ADDENDUM

AM 07

PROJECT : Forestside
PROJECT # : 1331.15
DATE : Dec 14, 2020

Title: Updated drawings

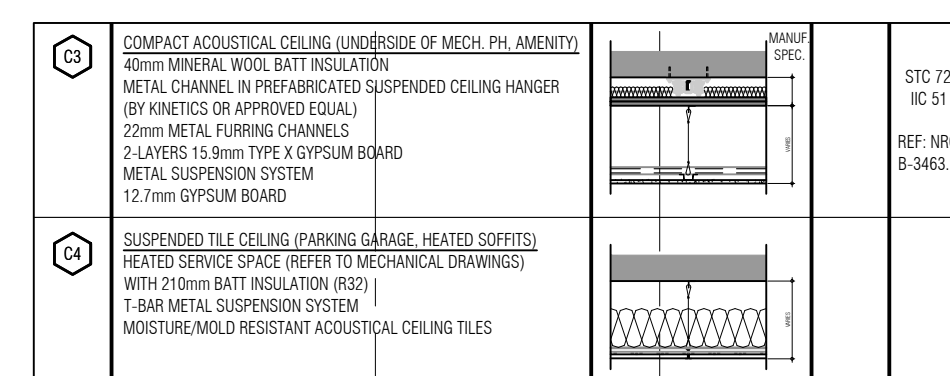
Reference:		Changes:
P1	Underground Plan	• Add concrete block with chain link fence above and note at underground garage door.
A301 A302 A303	Floor Plans	• Remove Garbage room door in link areas and extend closet depth to firehose cabinets.
A403 A404	Elevations Elevations	• Revise East West Elevation Orientation. • Revise North South Elevation Orientation.
